Historic Preservation Design Review

October 23, 2014

HP-14-19, 14-20 N. Main St. (City)

Request: Approval for Hotel Design

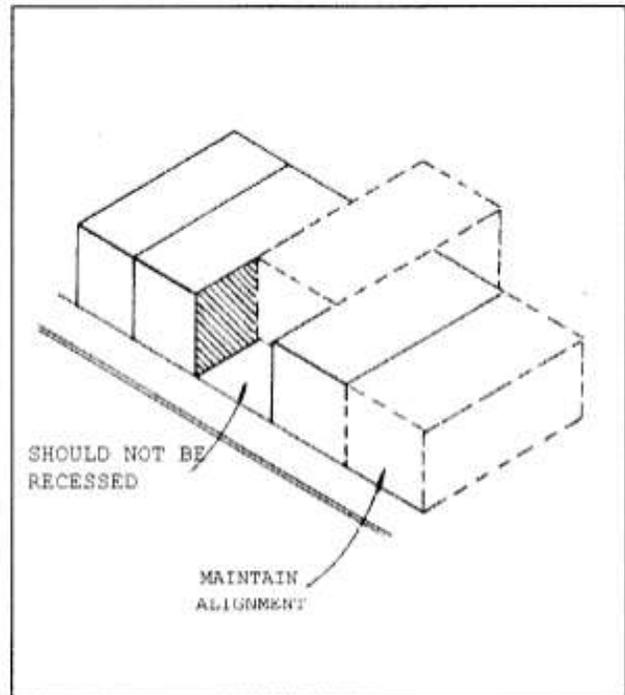
- The proposed hotel plan has primarily neoclassical reproduction elements in its design. The façade architecture has both Palladian and Romanesque influences, as well as Corinthian columns. The rear has modern elements such as the asymmetrical sunshade awnings.

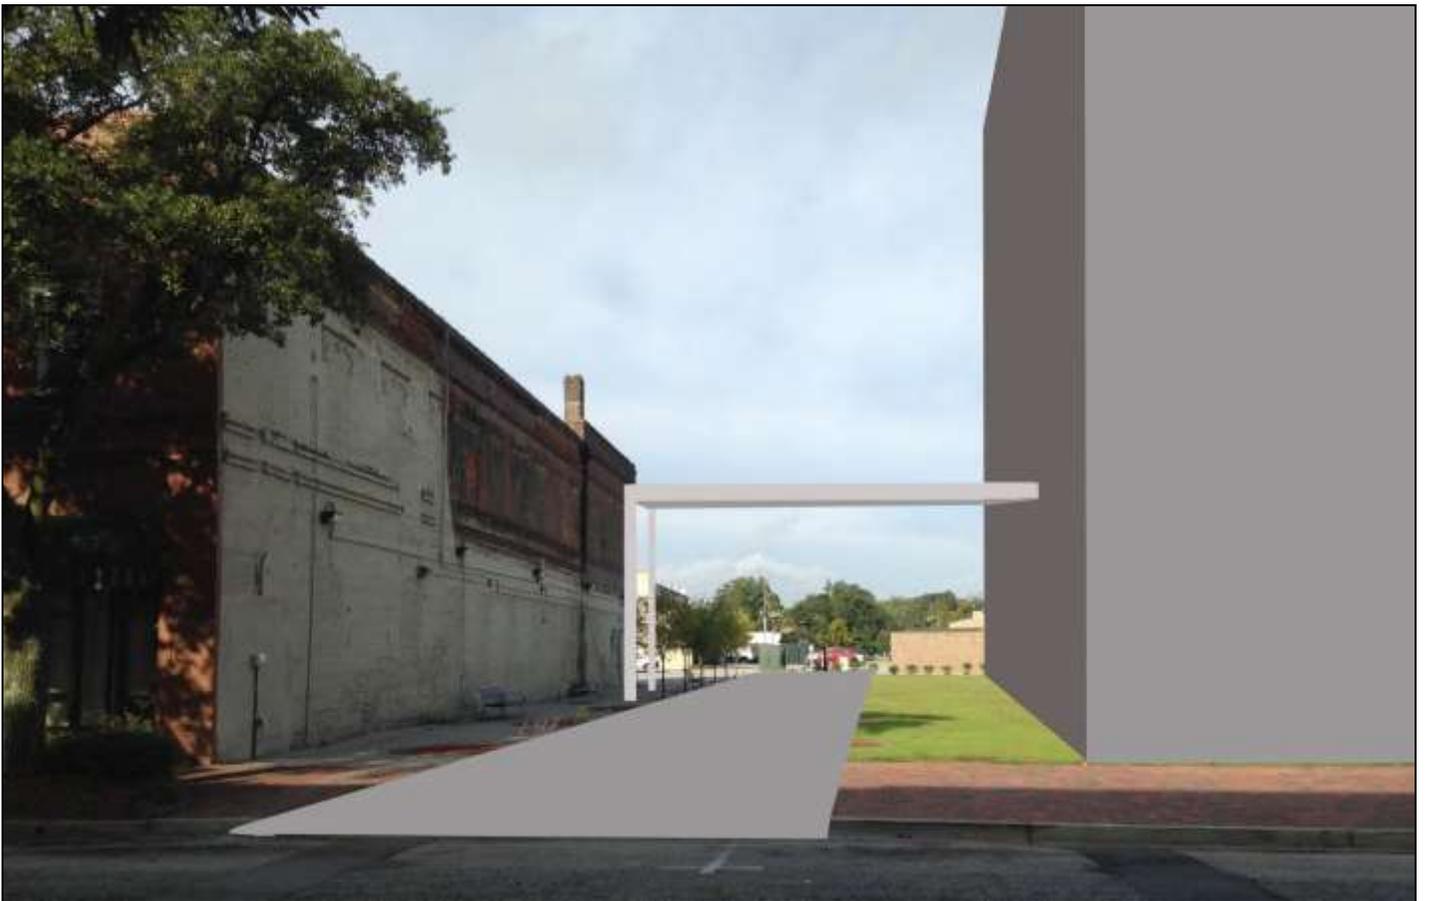
- The proposed building is set to the street as directed in the guidelines. However, the site design includes large open spaces on either side of the hotel, including a porte cochere on the side entrance of the building, which is a suburban design element and not suitable for a downtown. See graphics to follow:

The preferred design solution for Main Street urban fabric is to have continuous architecture that frames and defines the street. Because of the open spaces on either side in this proposal, fencing, gates, a narrow 12' entrance driveway, landscaping, and other site design elements are strongly recommended, to minimize the effect of wide open spaces along the Main Street urban fabric.

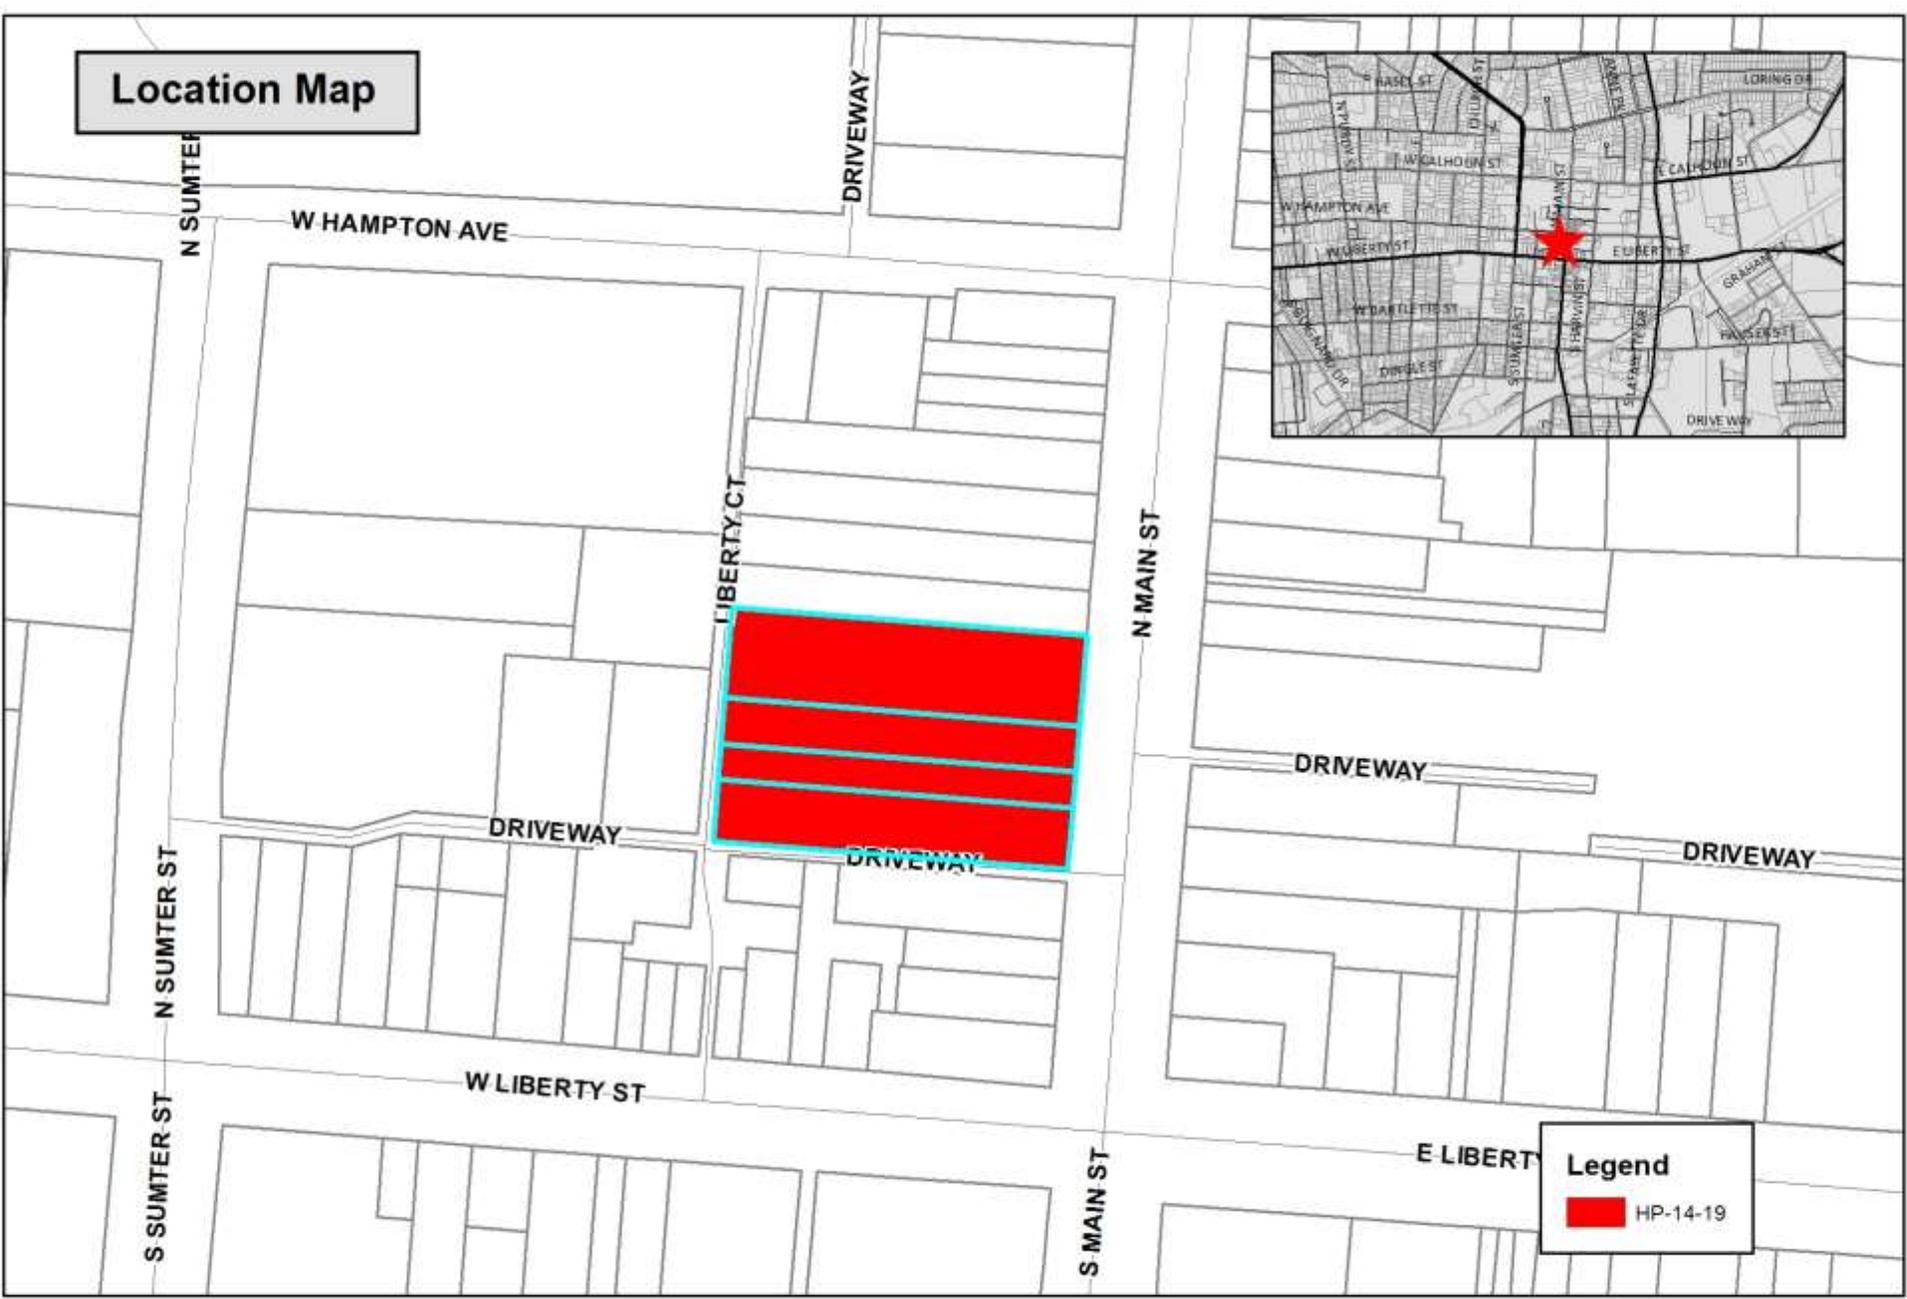
- The design of the hotel is not entirely consistent with guidelines. It is a reproduction of a combination of classical architectural styles.
- The open space on the right (north) side of the building will not be a public space, and therefore requires careful planning to create a private space that also maintains a quality pedestrian scale at the street level. It is understood that there will be a gate at the street, to separate the hotel open space.

- Urban framework requires close proximity of architecture in order to maintain walkability, a pedestrian environment and a downtown feel. There is a large amount of open space on either side of the proposed hotel, which needs to be addressed and minimized through good landscape and site design.

- The proposed one-way drive is simply too wide, and will have a negative effect on the downtown urban fabric. Instead, a smaller, 12' wide one-way driveway that widens once it reaches the porte cochere entrance is strongly recommended, along with fencing, gates, landscaping and other design elements to close the gap on the left / entrance side of the building.

- For pedestrian safety, staff recommends a cross walk at the drive entrance.
- A design for the gates, fencing and hotel open space will require separate historic preservation approval at a later date.
